PZBA13-00041                      3820 Skyline Avenue                      Anastacio & Floriza I. Valdez  
Applicants request a Special Exception under Section 2.16.050 J (Carport over a Driveway)  
in an R-4 (Residential) zone.

**RE:** PZBA13-00041, Structural Review

### MEMORANDUM

**ROOF PLAN**

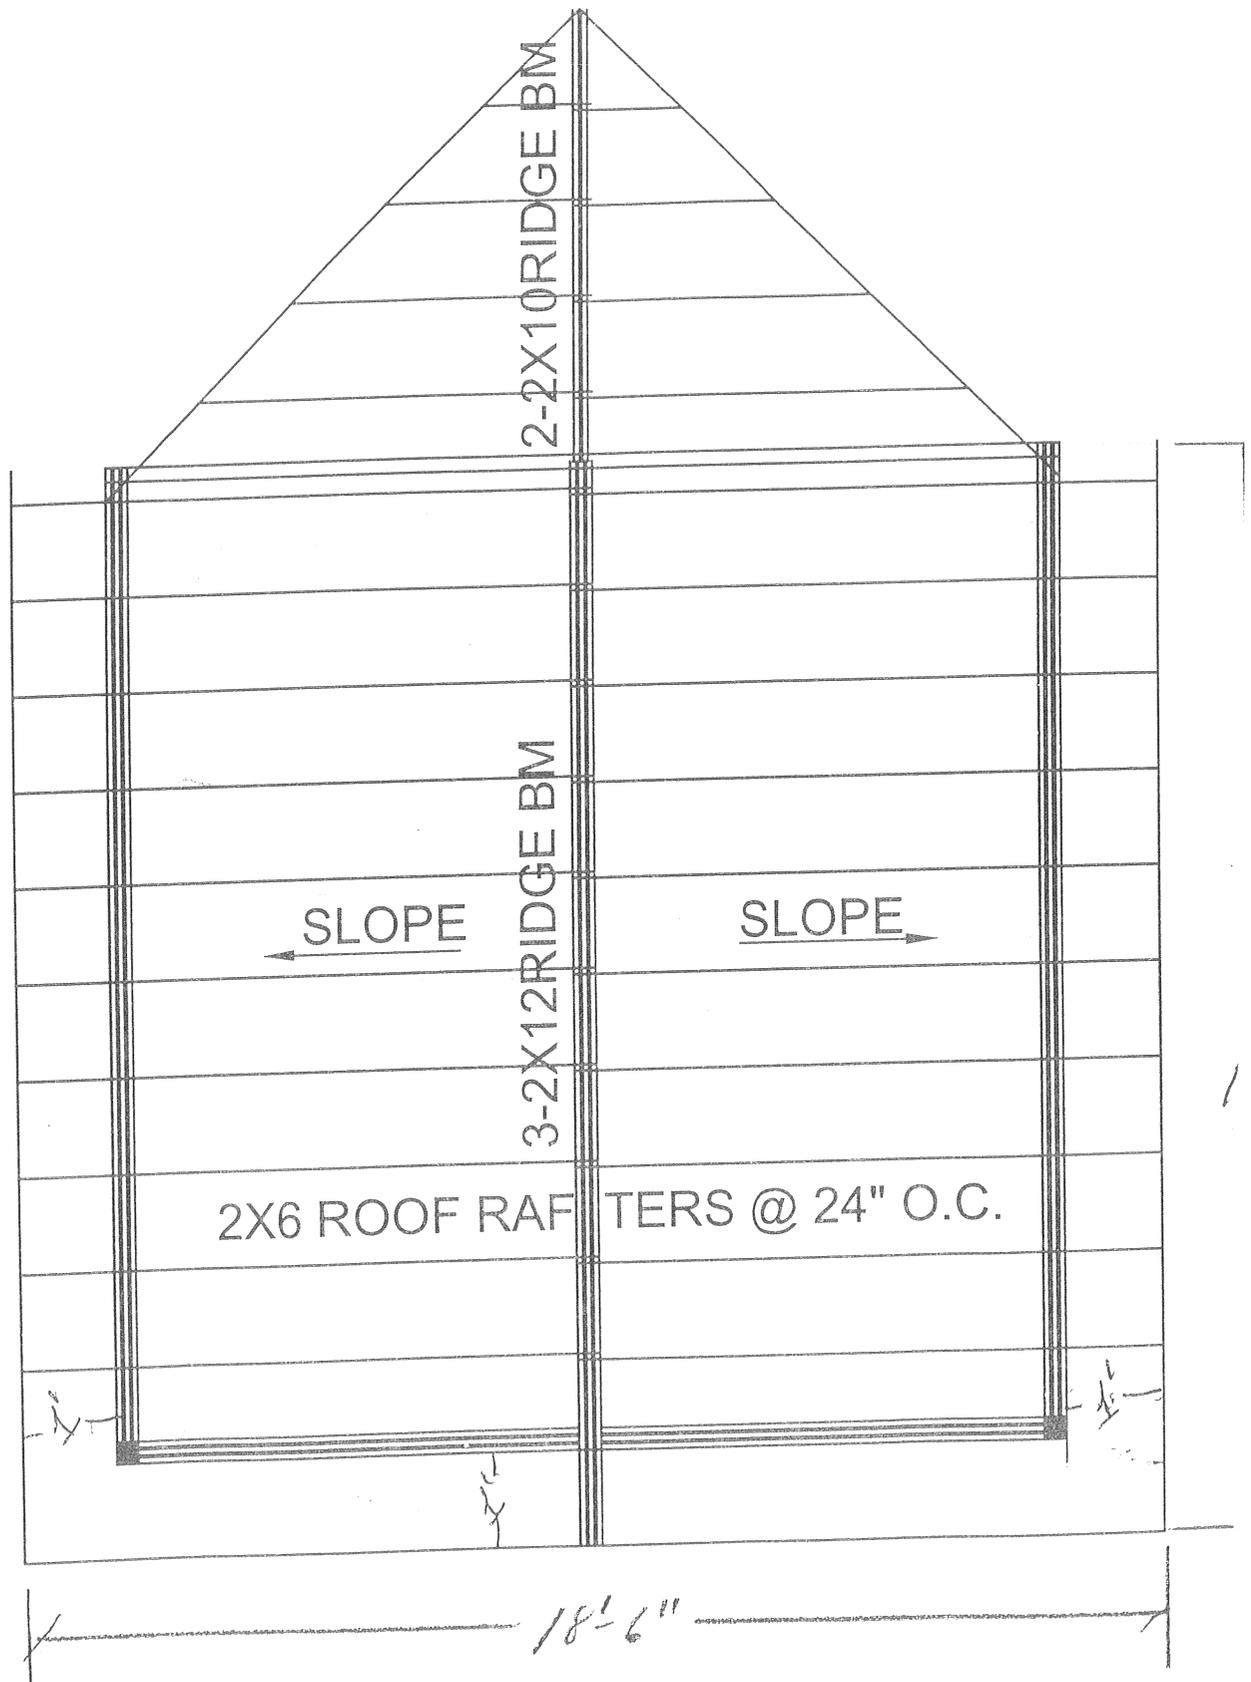
The applicant is requesting to build a carport over the driveway that will match the house in design and materials. There is no utility easement at the front property line. Building Permits & Inspections reviewed the structural plans and found them to be deficient due to over spanned beams throughout the structure. Should the special exception be granted, corrected plans will be required before the issuance of permits.

The carport's structural design has been reviewed and has been found inadequate, due to over spanned beams at the proposed carport and additional information required about the existing header above the garage door. These structural discrepancies do not affect the requested special exception but will need to be corrected, should the special exception be granted, prior to building permits being issued.

Staff recommendation is for approval of the request as it meets the requirements for the Special Exception J, with a condition that corrected plans are submitted per Building Permits & Inspections' structural report.
